Department:
Forestry, Fisheries and the Environment
REPUBLIC OF SOUTH AFRICA

Ref: EDMS - 216054

SUBJECT: COMMENTS ON THE COMMENTS ON THE DRAFT BASIC ASSESSMENT REPORT FOR ARCH ROCK ON REMAINDER PORTION 5 OF ERF 296, KEURBOOMSTRAND

Appendix A: Coastal Vulnerability Assessment of Portion 5 of farm 296

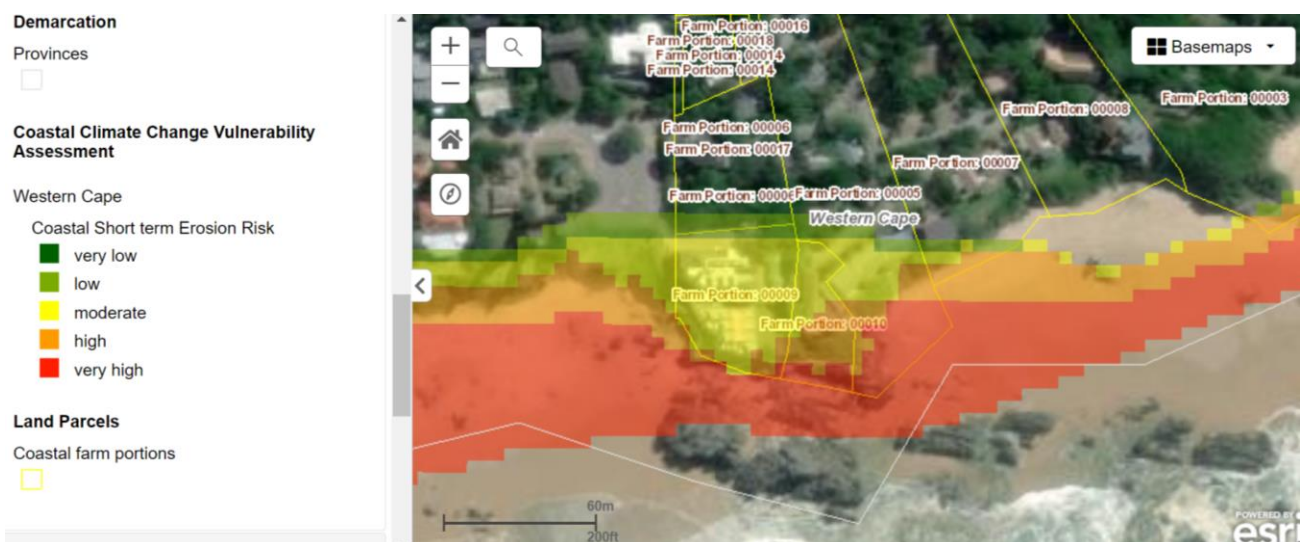
The beach area of the property is at a very high risk of flooding, while the foot of the slope has moderate to low flooding risk of flooding.

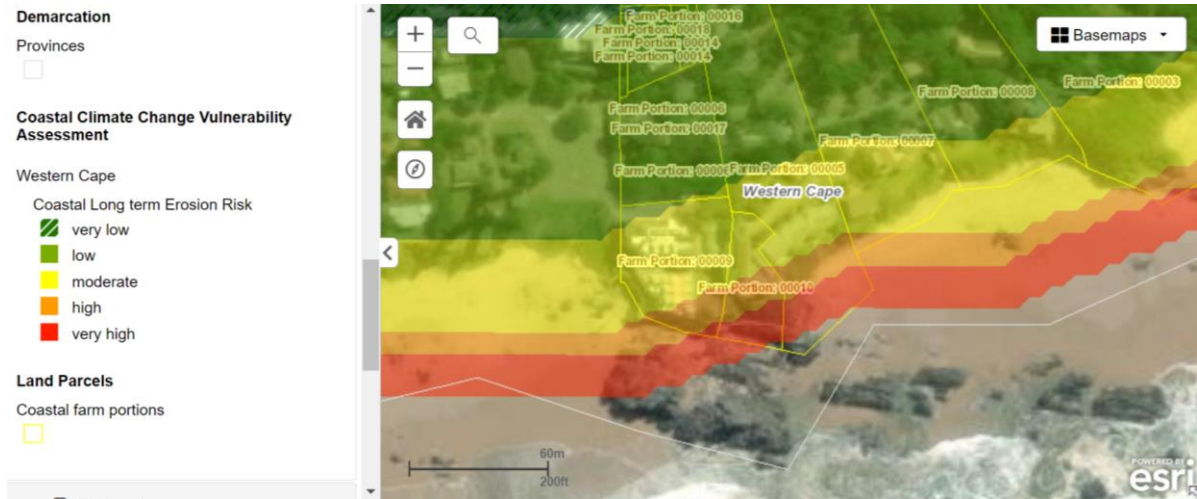
The property is located in an area that has short-term erosion risk ranging from very high to low. The slope has a high risk of eroding in the short term while the structures are located in an area that has moderate risk of short-term erosion.

The whole of portion 5 is within an area that is at risk of long-term erosion, ranging from very high to very low risk. The beach area has a very high to high risk of eroding, the slope has high to moderate risk of eroding and the structures located in an area that has moderate risk of eroding.
